Proposal for Supplement 17 to the 00 series of amendments to Regulation No. 87 (Daytime running lamps)

Submitted by the expert from Germany*

The text reproduced below was prepared by the expert from Germany updating the Conformity of Production (CoP) requirements. The modifications to the current text of the UN Regulation are marked in bold for new or strikethrough for deleted characters.

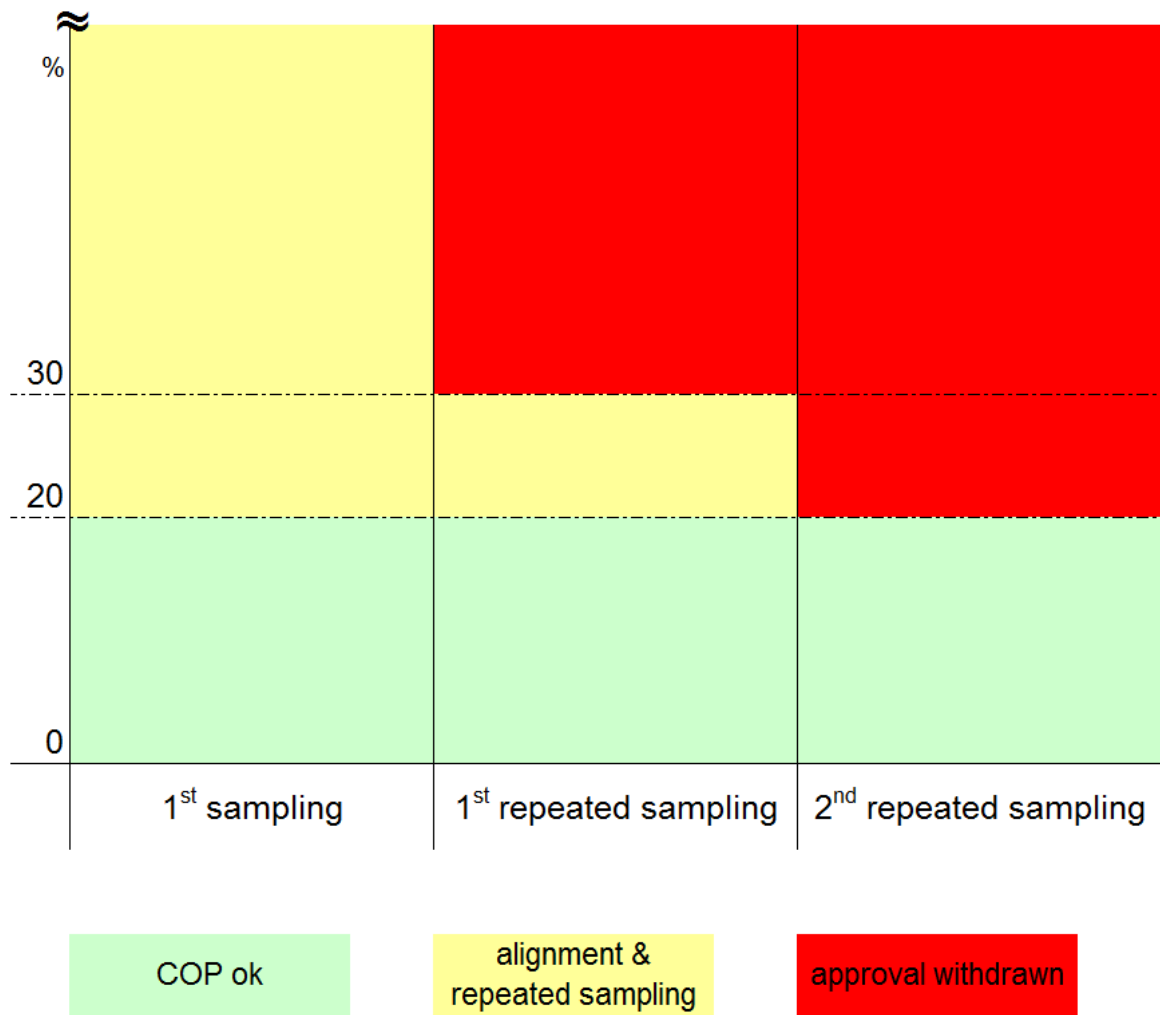
6. CoP is now described in a clear structured stepwise process (with limited steps), which gives the manufacturer the chance in the first step - in the case of deviations of more than 20 per cent - to align his production process. Also, the CoP process can be completed earlier when the first two samples are in the full specifications.

7. The proposal details the "third step" which defines the condition where the approval shall be withdrawn, when after the second repetition of this process the manufacturer was not in the position to "align" his production process in the correct way.

8. The attached drawing shall demonstrate this stepwise process.
